ASCE 41-17 Tier 1 and Tier 2 Seismic Evaluation Report Rossmoor Buildings:

600 Terra California Drive, Walnut Creek, CA

December 12, 2022

IDA Job No. 22054

MITIGATION PLAN

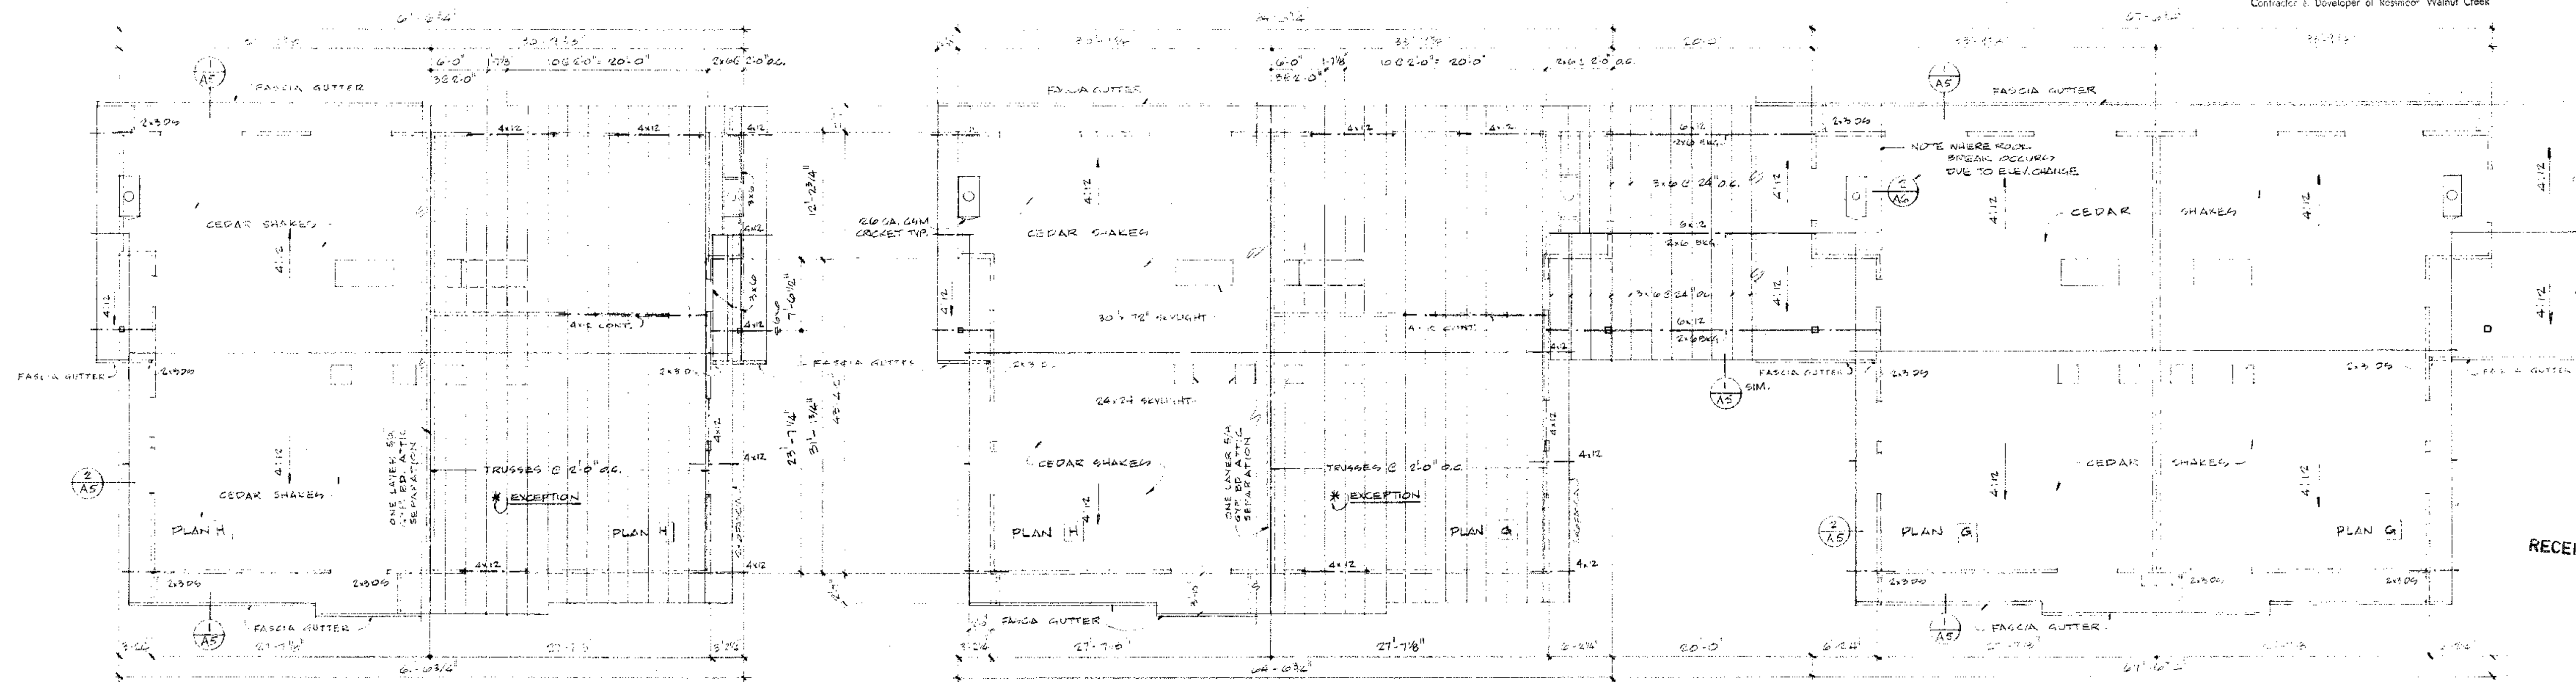
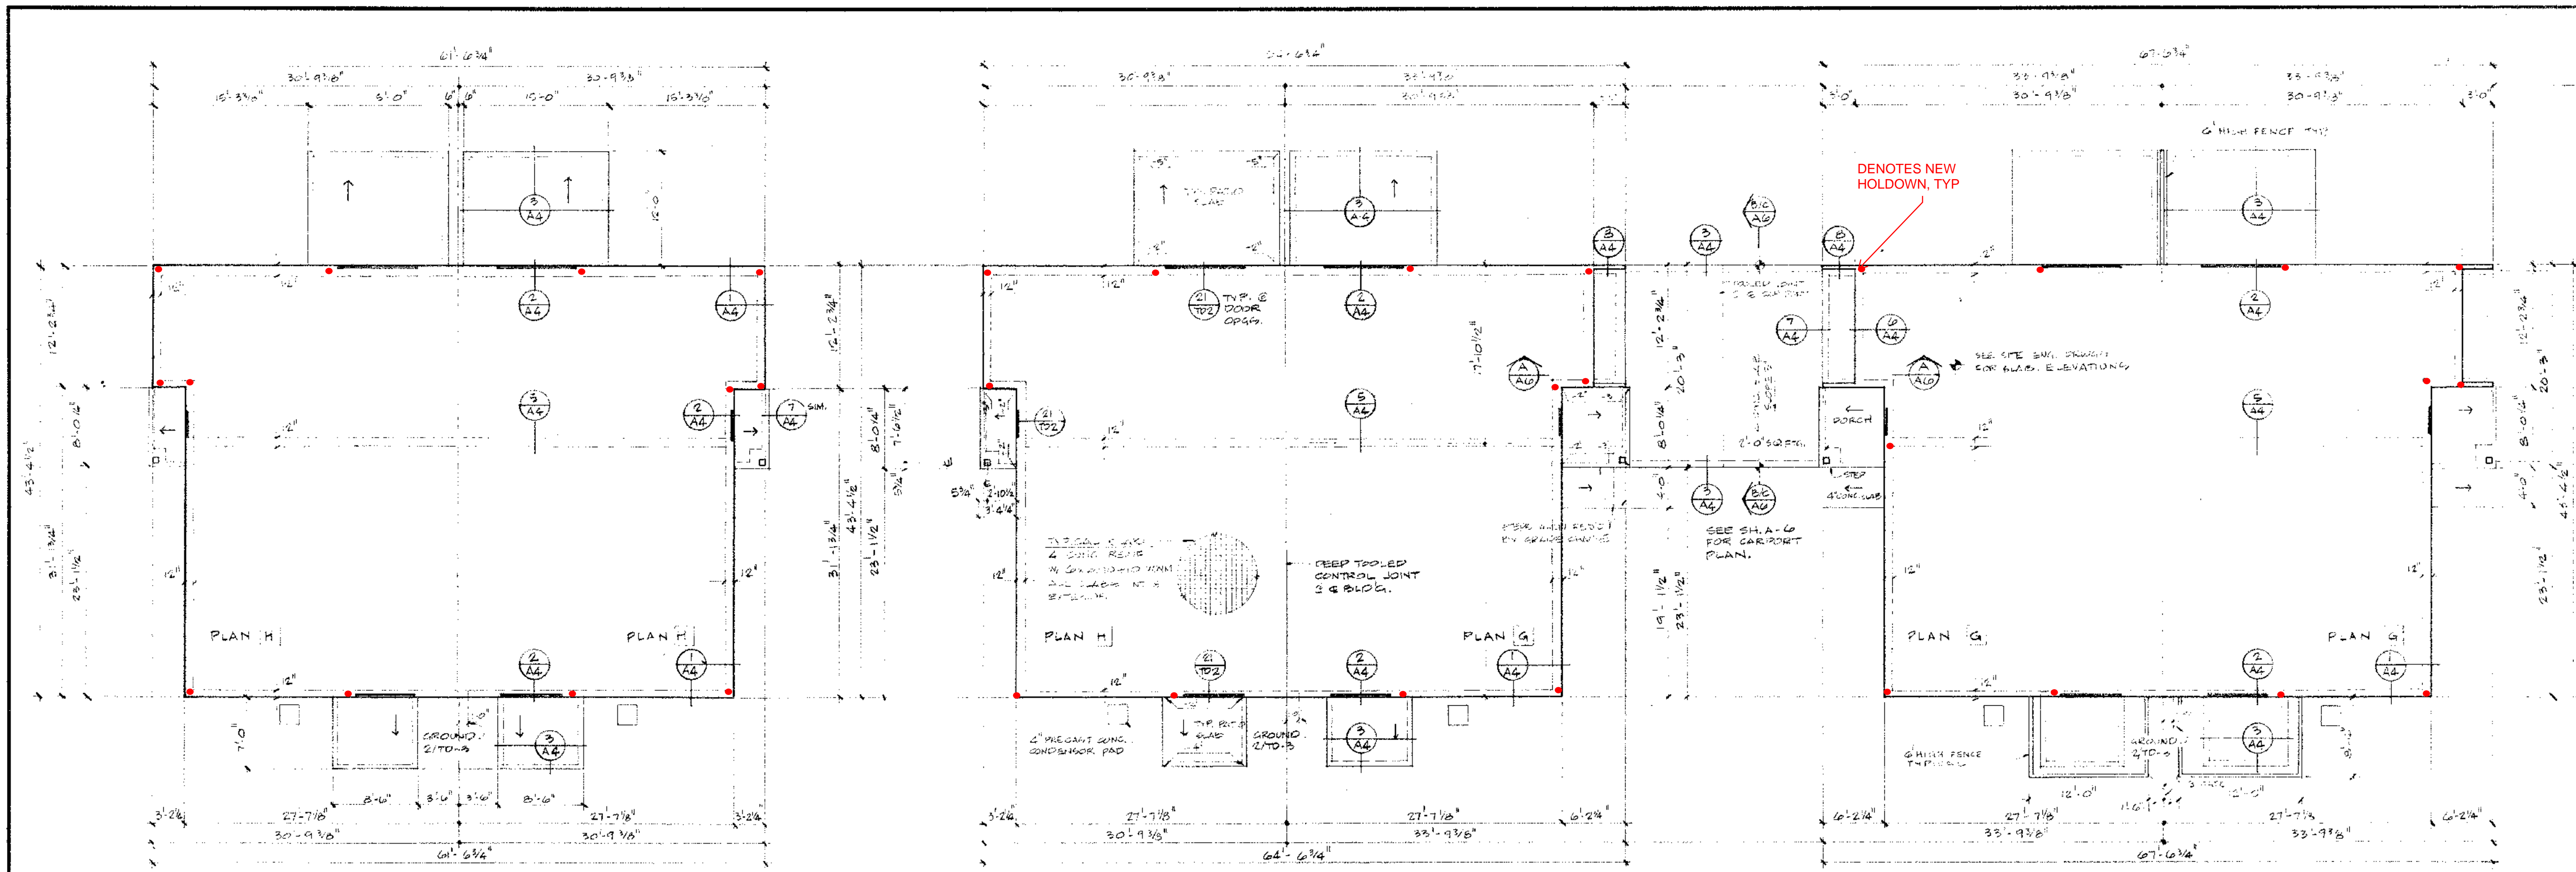
The shear walls do not have interconnection ties to transfer overturning forces through the floor. Shear walls in East-West direction do not have holdowns called out on the plans. Shear walls without holdown anchors may be subjected to significant overturning, and damage can be caused by uplift and racking of the shear walls. Hold down anchorage can help resist overturning forces and can greatly strengthen shear walls vs. walls without anchorage.

New straps can be added at shear walls to transfer overturning forces between floor to floor. Shear walls without hold downs should be retrofitted with hold down hardware and compression posts. New hold down hardware could be retrofitted at shear wall ends and anchor bolts would need to be epoxied into the existing foundations. Compression posts could be installed along with the hold down hardware as required. Foundation strengthening may be required if existing foundations are shallow or weak in local areas.

DEFICIENCIES AND MITIGATIONS

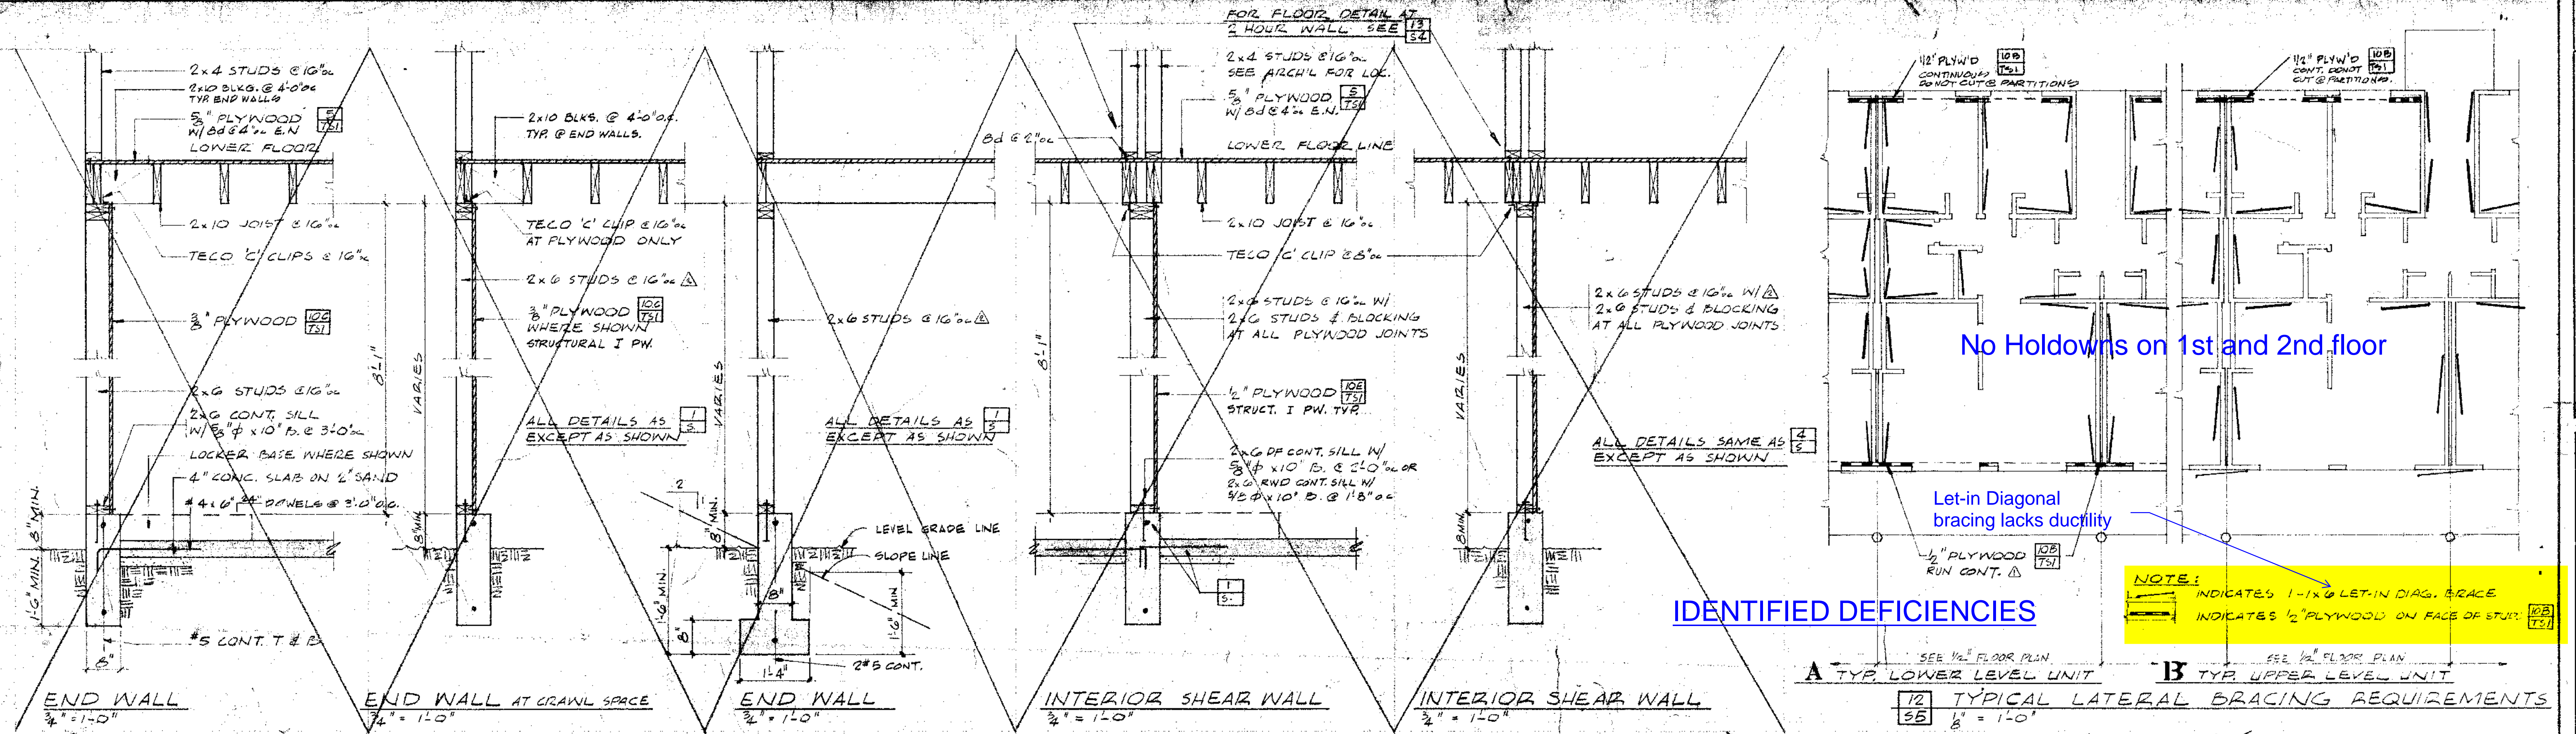
The shear walls do not have interconnection ties to transfer overturning forces through the floor. Shear walls in East-West direction do not have holdowns called out on the plans. Shear walls without holdown anchors may be subjected to significant overturning, and damage can be caused by uplift and racking of the shear walls. Hold down anchorage can help resist overturning forces and can greatly strengthen shear walls vs. walls without anchorage.

The building is lateral braced by a combination of let-in diagonal bracing and shear walls. Let-In bracing is a diagonal wood member which is recessed or "let-in" to the wall studs to provide lateral load resistance. This bracing system lacks the ductility of plywood shear walls and are not desirable as a primarily lateral load resisting system for the building. This lateral load resisting system is not permitted in new construction under current building loads.

New straps can be added at shear walls to transfer overturning forces between floor to floor. Shear walls without hold downs should be retrofitted with hold down hardware and compression posts. New hold down hardware could be retrofitted at shear wall ends and anchor bolts would need to be epoxied into the existing foundations. Compression posts could be installed along with the hold down hardware as required. Foundation strengthening may be required if existing foundations are shallow or weak in local areas.
